FDOT INDEX #200/211 TYPE 5 CURB INLET # S-101

FDOT 434986-1-52-01

STRAIGHT AHEAD CONSTRUCTION

FORTERRA | PIPE & PRECAST

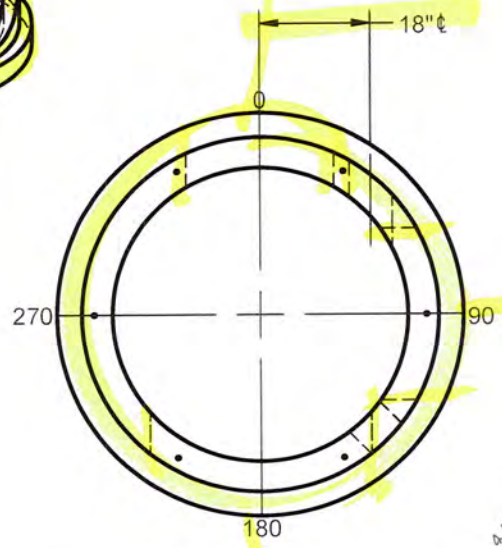
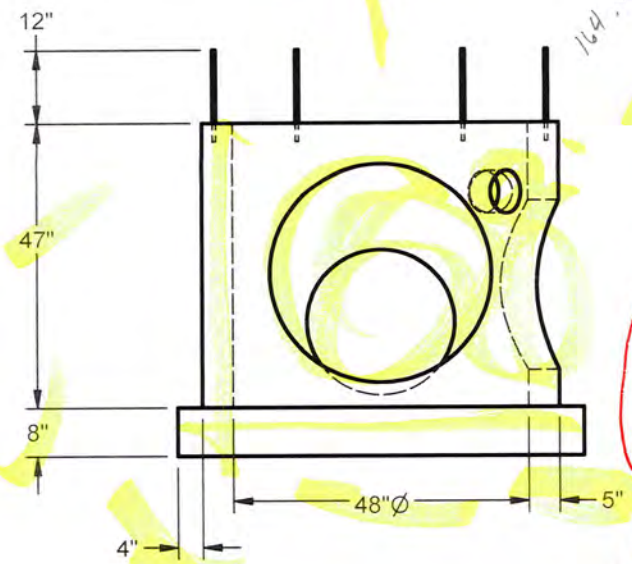
164.94 - 105+5/12 =

EOP = 164.94

TPW1 = 163.63 .65

ITB = 159.71

APTB = 3.94

163.65 - 159.71

☑ Make corrections noted ☐ Rejected (See Remarks)
